INFORMATION LETTER 407-05-87

SUBJECT: FILTER 50-075-1, INSPECTION AND RECALL OF

Figure 1. Filter 50-075-1 Physical Difference

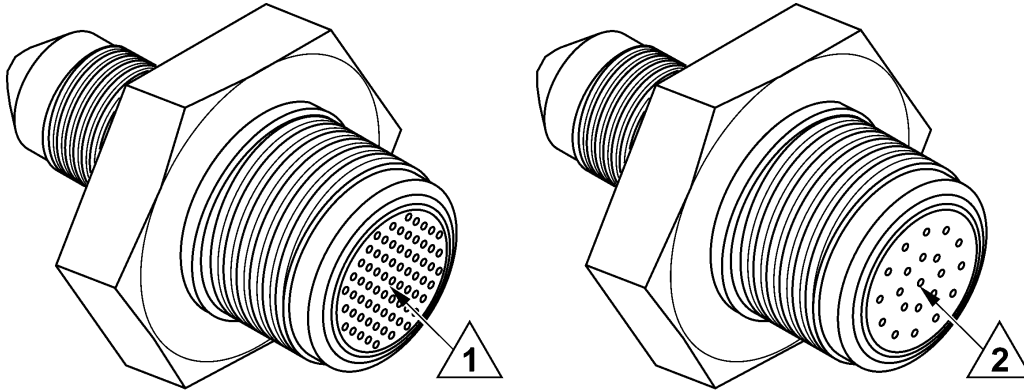
This information letter is issued to report that in some filter units 50-075-1, the screen portion of the filter was not manufactured with the correct number of holes. Testing has confirmed this condition is not detrimental to the normal operation of the transmission and freewheel oil system. However, Bell Helicopter recommends that filter units with an incorrect hole pattern be identified and replaced.

To identify the configuration to be removed from service, examine the screen hole pattern (refer to Figure 1). Replace any unacceptable filter unit at your earliest convenience.

- 1** Acceptable hole pattern. A minimum of 65 holes are required.
- 2** Unacceptable hole pattern to be removed from service.

Bell Helicopter will supply parts necessary to perform this task, consisting of packing M83248/1-906 and filter 50-075-1, at no charge. This credit is available for non-compliant filters that are installed or in stock.
